Board of Architectural Review

DATE: March 6, 2024
TO: Board of Architectural Review Chair and Members
THROUGH: Jason Sutphin, Community Development Division Chief *JDS*
FROM: Anna Kohlbrenner, BAR Liaison *AK*
SUBJECT: **Work Session: 10120 Fairfax Blvd – Taco Bell**

1. Case Number:	BAR-24-00087
2. Address:	10120 Fairfax Blvd
3. Request:	Restaurant with drive-through
4. Applicant:	ABTB Mid-Atlantic LLC
5. Applicant's Representative:	Kathryn R. Taylor
6. Status of Representative:	Attorney
7. Zoning:	CR Commercial Retail, Architectural Control Overlay District

SOUTH ELEVATION

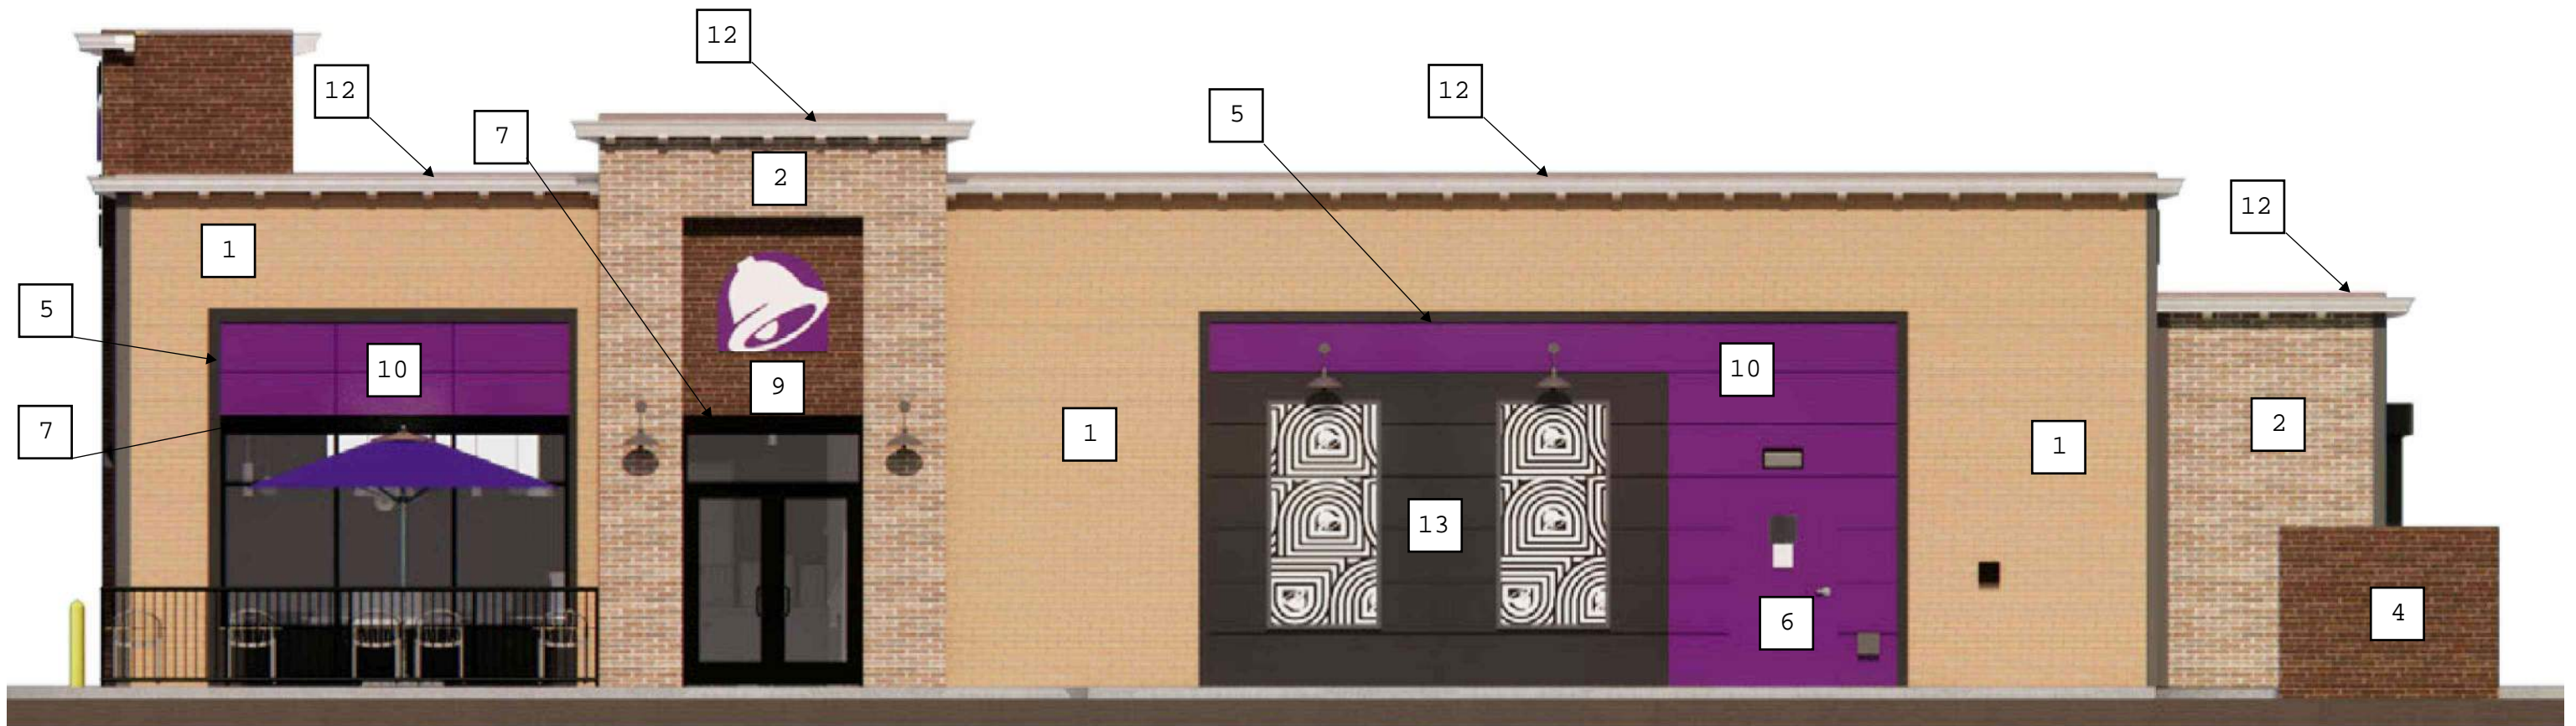
The main entrance faces Fairfax Blvd showing signage, a door, and outdoor dining area.

The applicant is proposing different materials and textures throughout the building to break up the façade. The massing of the building along Fairfax Blvd is under 30' wide, but the applicant still breaks up the façade to show different heights and dimensions. The main architectural corner is higher than the rest of the building. Human scale is introduced by the implementation of an outdoor dining area.

The roofline matches the surrounding shopping center and mechanical would be hidden from view. The cornice appears slightly out of proportion.

SIGHT-LINE FOR ROOFTOP EQUIPMENT SCREENING

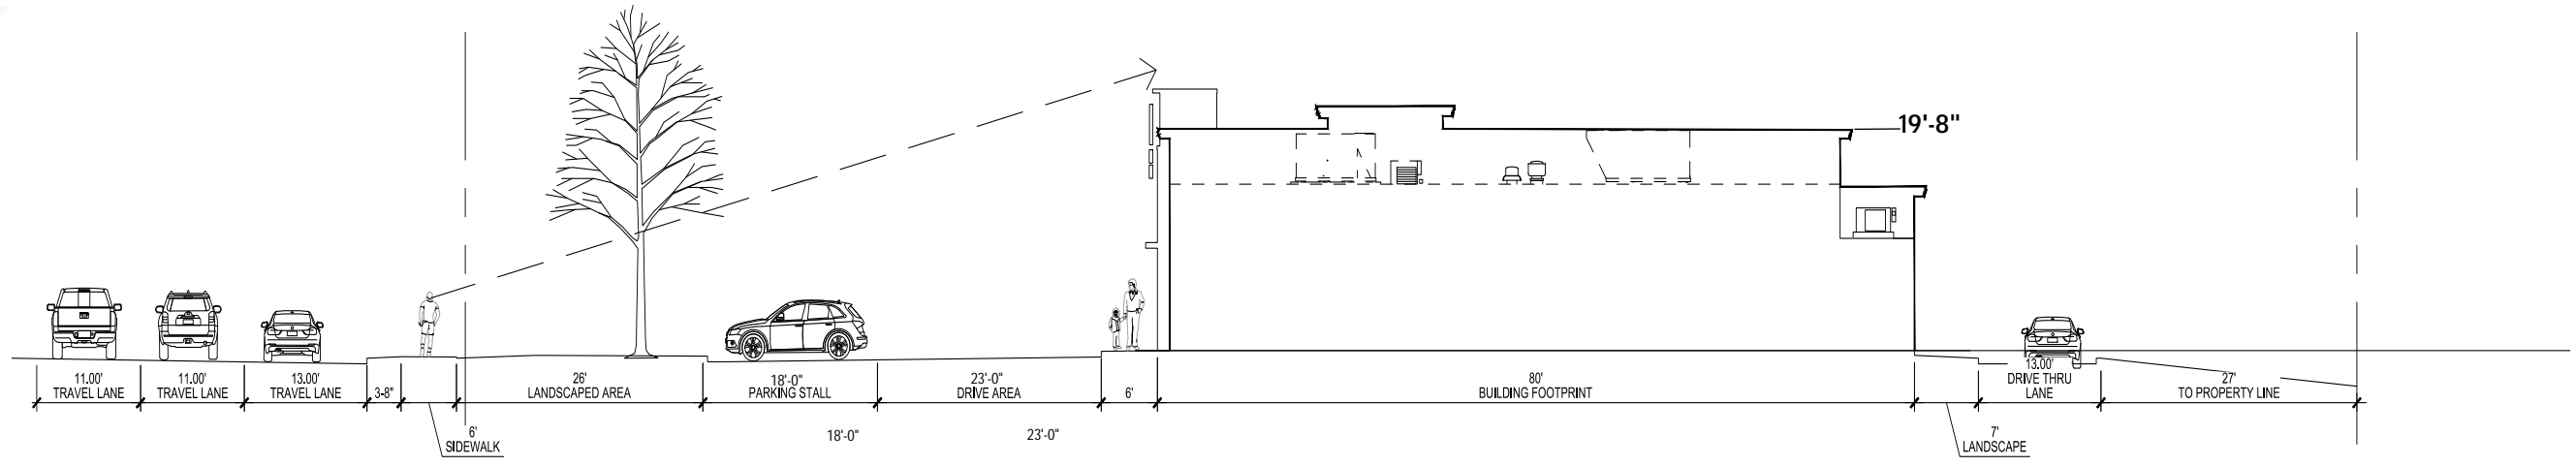
Roof-top mechanical would be fully screened by the roofline and would not be visible from the ROW in any direction.
